Pender County Planning and Community Development

MEMORANDUM

RE: Upcoming Public Hearing on UDO Section 7.5 Street Design

FIGURE G1

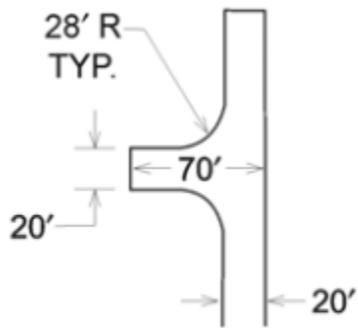
- 1) **A cul de sac with at least 90-feet of right of way including 80-feet of pavement.**
- 2) **A Y intersection (See Figure G1 for specifications)**
- 3) **A T Intersection (See Figure G2 for specifications)**
- 4) **A T/Hammerhead intersection (see Figure G3 for specifications)**
